**KANE PACKAGE PHILIPPINE INC.**

INVESTIGATION REPORT FORM (IRF)

Control No.:	Date Issued
0089	250510

Customer	HIBLOW PHILIPPINES INC.	Attention To	REXEL ALMARIO
Item Code	DB08005130-00	Department	PRODUCTION
Item Description	XP BOX PROTOTYPE OUTER BOX AND INSERT PAD	Date of Detection	250503
Job Order Number	JO25-M-01315-1	Section Detected	QA SCREENING

ILLUSTRATION OF THE PROBLEM**ACTUAL:** With peel off up to 30mm**REQUIREMENT:** Acceptable up to 25mm

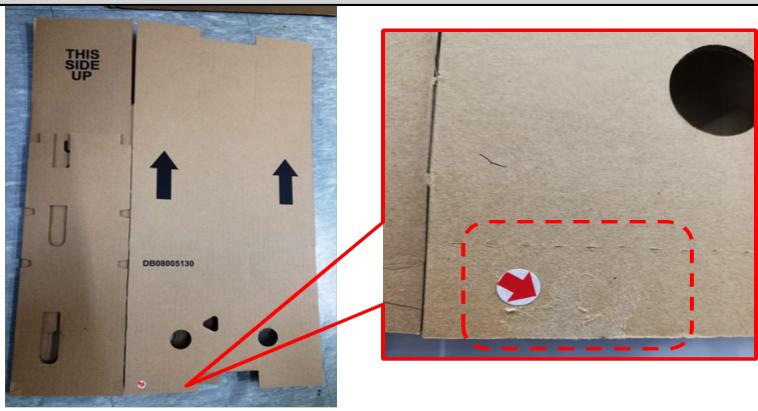
PEEL OFF

With peel off up to 30mm

WHY 1 : PEEL OFF OCCURRED DURING DETACHING PROCESS

WHY 2 : PRESENCE OF UNCUT LINER DURING ETERNA PROCESS

WHY 3 : IMBALANCE DIECUT PRESSURE DUE TO UNEVEN APPLICATION OF BACKING TAPE

WHY 1: APPLICATION OF BACKING TAPE TO THE AFFECTED PORTION
